ITEM: 6.2	COMMITTEE OF ADJUSTMENT REPORT SUMMARY MINOR VARIANCE APPLICATION FILE NUMBER A025/23 153 POLO CRESCENT, WOODBRIDGE
------------------	--

**COMMITTEE OF ADJUSTMENT REPORT
MINOR VARIANCE APPLICATION
A025/23
153 POLO CRESCENT, WOODBRIDGE**

ITEM NUMBER: 6.2	CITY WARD #: 3
APPLICANT:	Angela Coluccio and Fabio Oliveira
AGENT:	Robert Pasutto
PROPERTY:	153 Polo Crescent, Woodbridge
ZONING DESIGNATION:	See Below
VAUGHAN OFFICIAL PLAN (2010) DESIGNATION:	Vaughan Official Plan 2010 ('VOP 2010'): "Low-Rise Residential"
RELATED DEVELOPMENT APPLICATIONS:	None
PURPOSE OF APPLICATION:	Relief from the Zoning By-law is being requested to permit the construction of a proposed pavilion, an existing shed and reduced landscaping requirements in the rear yard.

SCALE: 1:200
DATE: 2023-05-23
DESIGN: POOL PERMIT PLAN

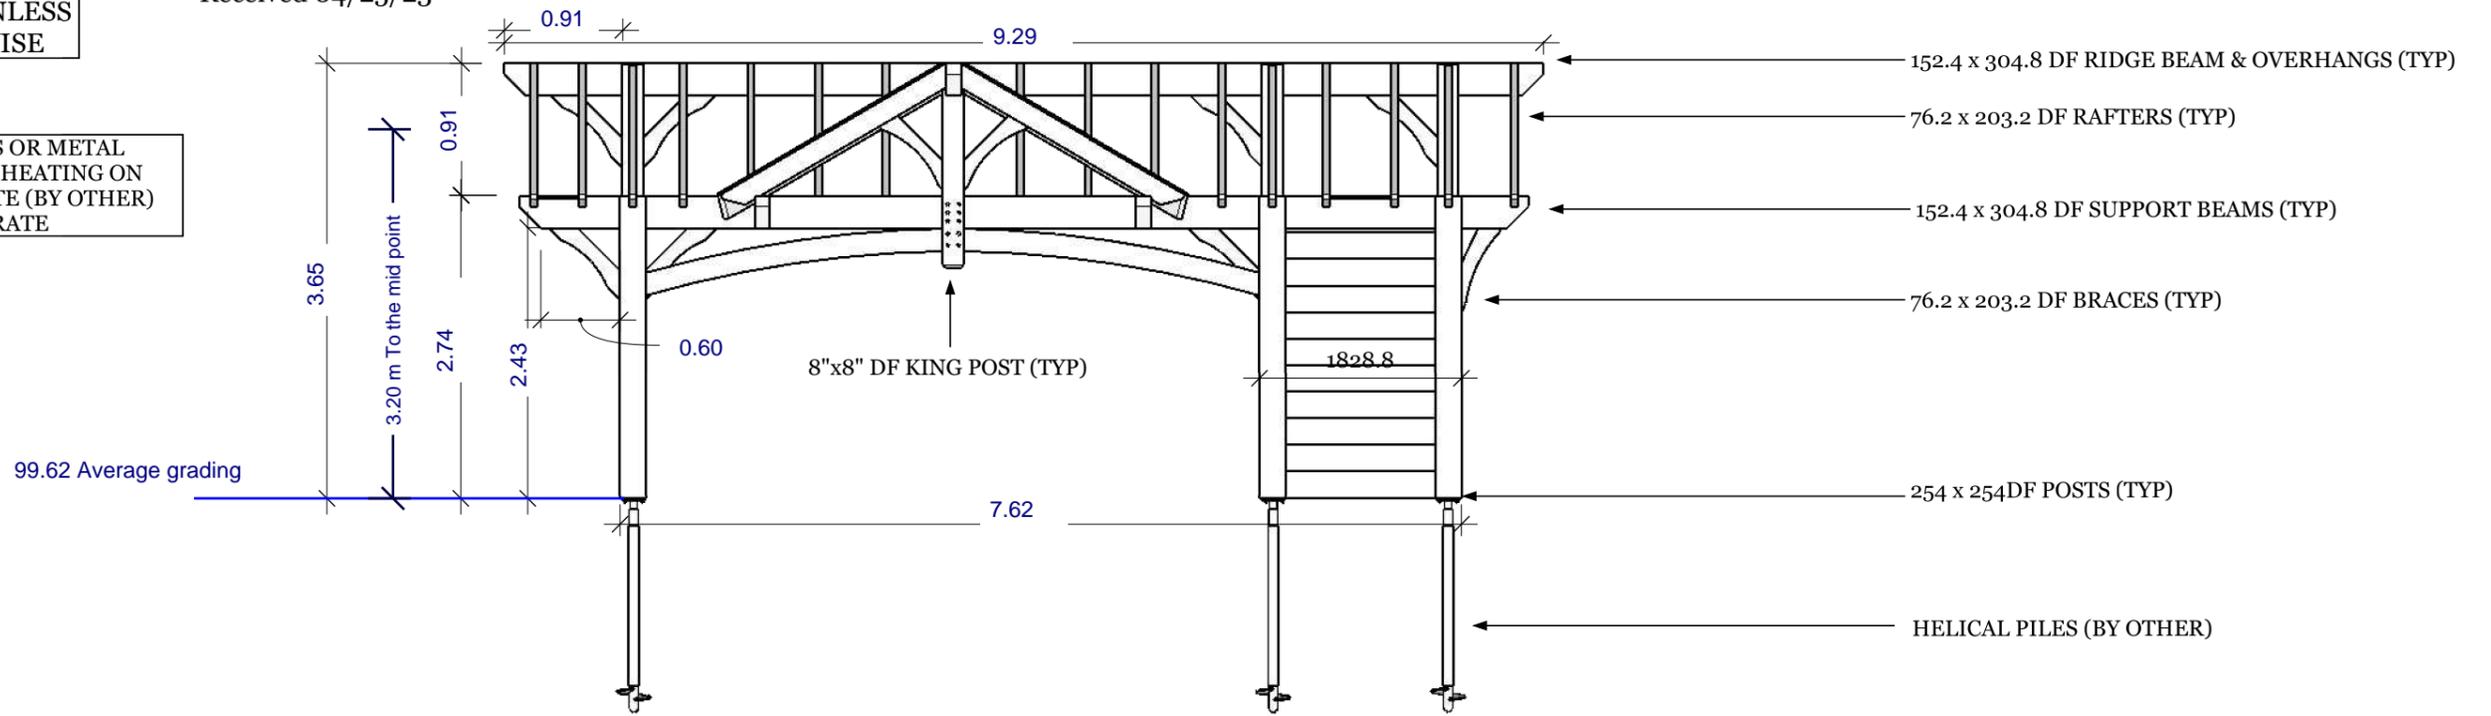
As the proposed structures in the subject property is more than 10 m² (in-ground pool is 50.16 m² and pavilion is 32.52 m²), the Owner / Applicant needs to obtain a Lot Grading Permit from Development Inspection and Lot Grading Division of the City's Development Engineering Department. Please note any in-ground structure over 10 m² requires a Grading Permit. Please contact the Development Engineering Reviewer after receiving the Grading Permit to clear the condition. (Condition attached)

The Owner / Applicant shall apply for a Pool Grading Permit with the Development Engineering (DE) Department. Please visit the grading permits page at City of Vaughan website to learn how to apply for the Pool Permit. If you have any question about Pool Grading Permit, please contact the Development Engineering Department through email at DEPermits@vaughan.ca.

The proposed work by the Owner / Applicant is increasing the lot coverage on the subject property. The added hardscape may have impacts on the City's Storm Water management system. Development Engineering strongly encourages the Owner / Applicant introduce Low-Impact Development (LID) measures (e.g., bioswales, permeable pavers, rain gardens, rain barrels etc.) to reduce the impacts to the stormwater system. Should further information be required, please contact the Development Engineering COA reviewer.

Development Engineering Recommended Conditions of Approval:	The Owner / Applicant shall submit the final Lot Grading and/or Servicing Plan to the Development Inspection and Lot Grading Division of the City's Development Engineering Department for final Lot Grading and/or Servicing Permit prior to any work being undertaken on the property. Please visit the Grading Permit page at City of Vaughan website to learn how to apply for the Grading Permit. If you have any questions about Grading Permit, please contact the Development Engineering Department by email at DEPermits@vaughan.ca.
--	--
